Re: The Boeing Company
IBFS File No. SAT-LOA-20170301-00028
Call Sign S2993

On behalf of The Boeing Company (“Boeing”), we hereby respond to the questions raised in your letter dated June 22, 2017.¹ As a result of Boeing’s responses, Boeing has made the following revisions to its Schedule S for the above-referenced application:

Figure 1 – LEO to Ka-band GSO Relay and Ka-band GSO "Victim" Satellite Scenario

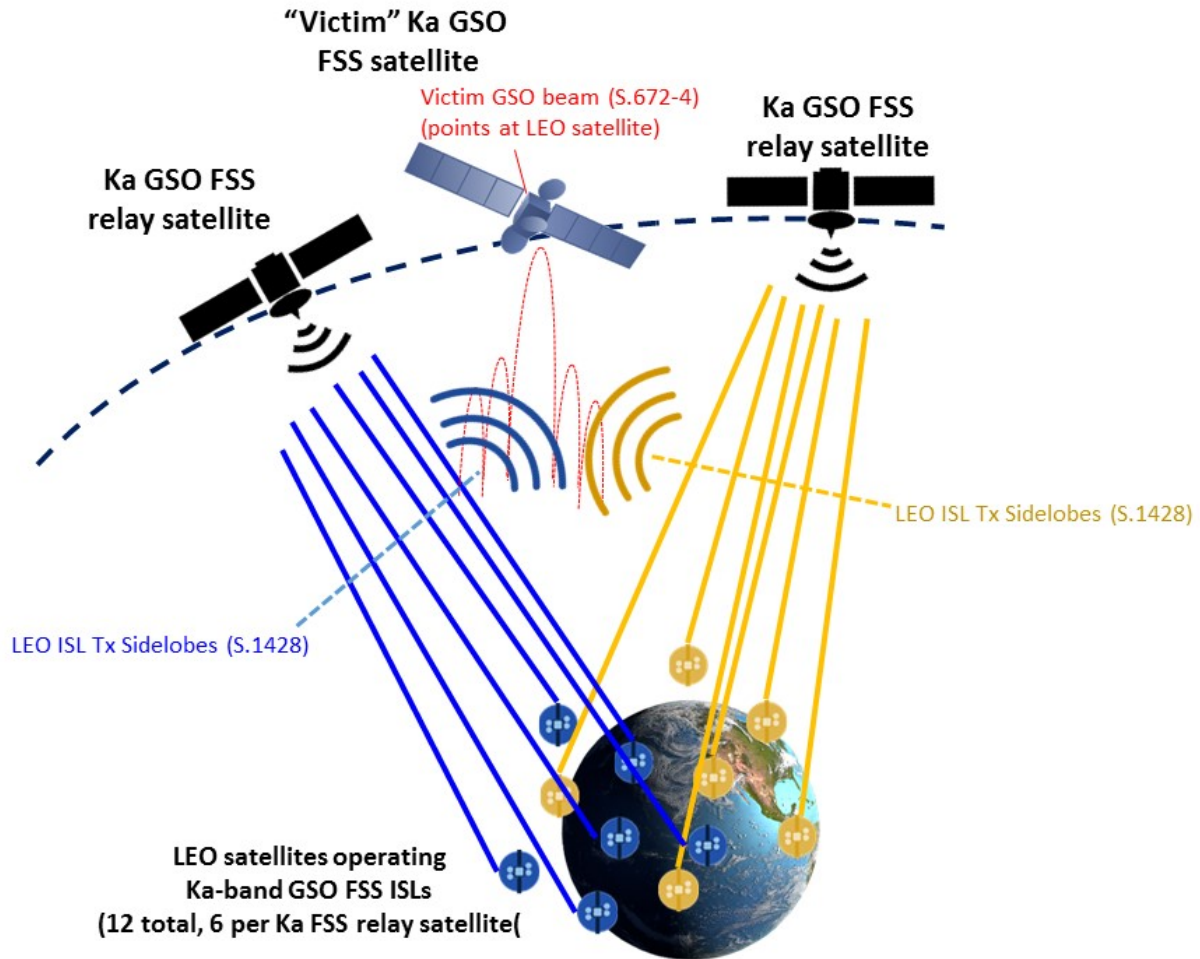
9. *Article 22 of the ITU Radio Regulations specifies equivalent power flux-density (epfd) limits that are applicable in several frequency bands in which Boeing proposes to operate. These include epfd_{up} limits in the 27.5-28.6 GHz and 29.5-30 GHz bands. Please provide a showing demonstrating the Boeing satellite system's compliance with the applicable epfd limits specified in Article 22 of the ITU Radio Regulations in these frequency bands.*

Currently, there is no approved ITU software that can compute an EPFDup level with sources operating on LEO satellites. Nevertheless, Boeing has computed the EPFDup generated by its proposed Ka-band ISL operations in a scenario that reflects heavy usage of Ka-band ISLs by Boeing's LEO constellation. The specific scenario, shown in Figure 1, assumes a total of twelve LEO satellites using ISLs to transmit to two relay satellites in geostationary orbit ("GSO"), which are each spaced at two degrees east and west of a separate Ka-band GSO satellite, which represents the "victim" Ka-band GSO satellite experiencing interference from the Boeing ISL operations. Six LEO satellites are communicating with each GSO relay satellite and are operating a maximum uplink PFD level consistent with the EIRP density in the Boeing application and taking into account free-space path loss to the GSO satellite(s). The Boeing LEO satellite ISL beam patterns are consistent with a 1.2 degree beamwidth and use the ITU-R S.1428 beam patterns (for earth stations), while the victim GSO satellite beam is consistent with the 1.55 degree ITU-R S.672-4 beam pattern specified in the ITU Radio Regulations for EPFDup

computations. The victim GSO beam is pointed at the worst-case location, which is directly overlapping one of the LEO satellite(s). Figure 2 below illustrates the results of the EPFDup modeling over the LEO constellation orbit variations.
